Schedule B-3 – Purchaser’s Extras

LOT NUMBER: 135 PHASE: 1

MODEL: Madawaska 3190 – ELEV. A

The Madawaska / Elev. A & B
3190 sq.ft.

LOT 1-135 - BUILT-IN APPLIANCES

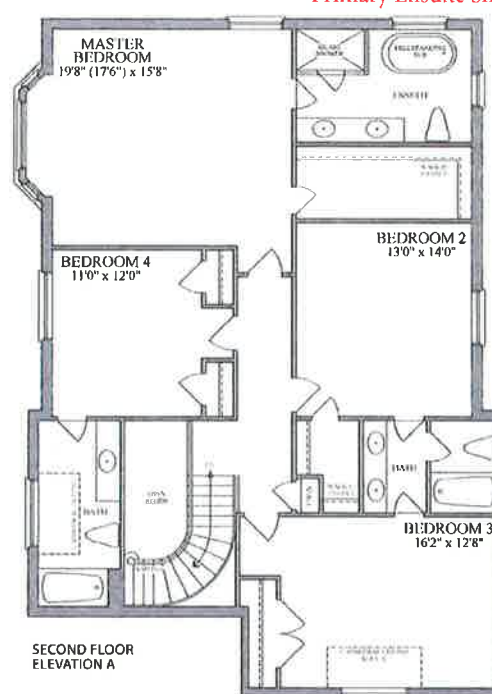
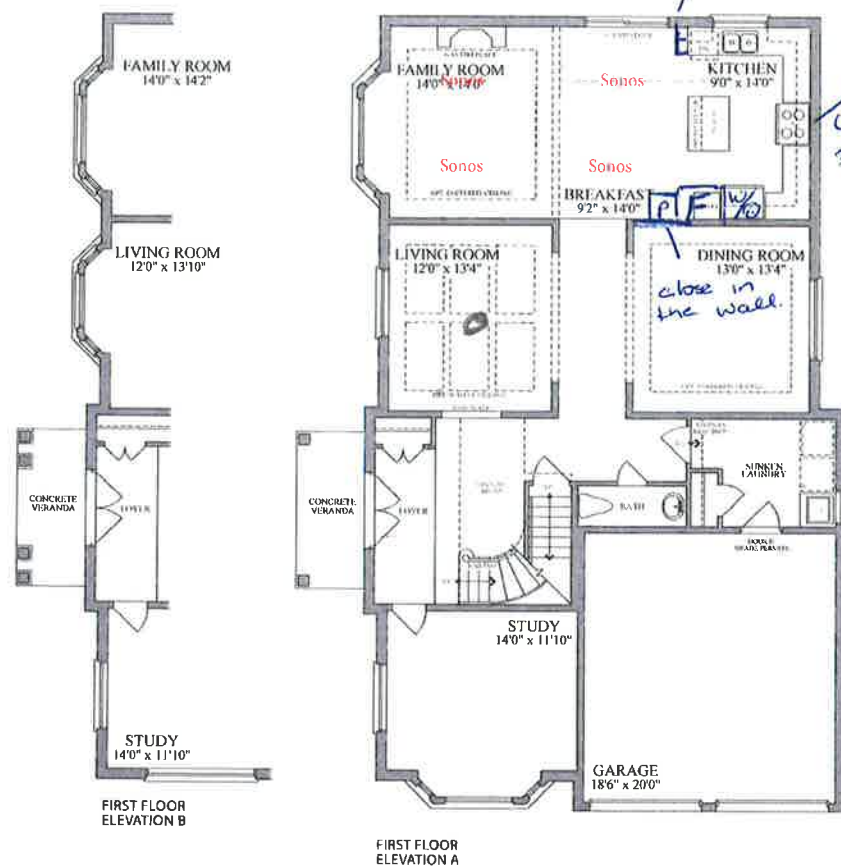
In order to accommodate Built-in Appliances

1. Close the opening into the Dining Room from the Kitchen.
2. Shift the Pantry and Fridge over.
3. Add 1 1/2ft kitchen extension to accommodate wall oven.
4. Provide specs for 30" or 36" cooktop
5. To balance kitchen, add an additional foot of upper/lowers on the sink wall

The above reflects what needs to be done in order to accommodate Built-in appliances properly.

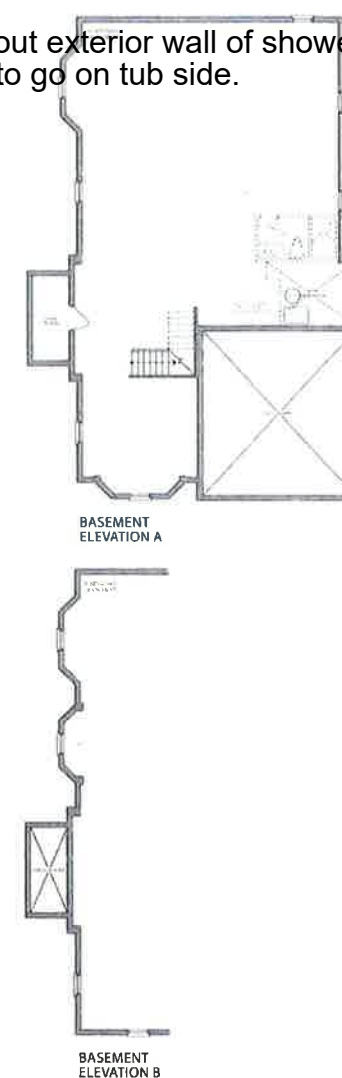
add shower seat and niche in Primary Ensuite Shower
Furr out exterior wall of shower seat to go on tub side.
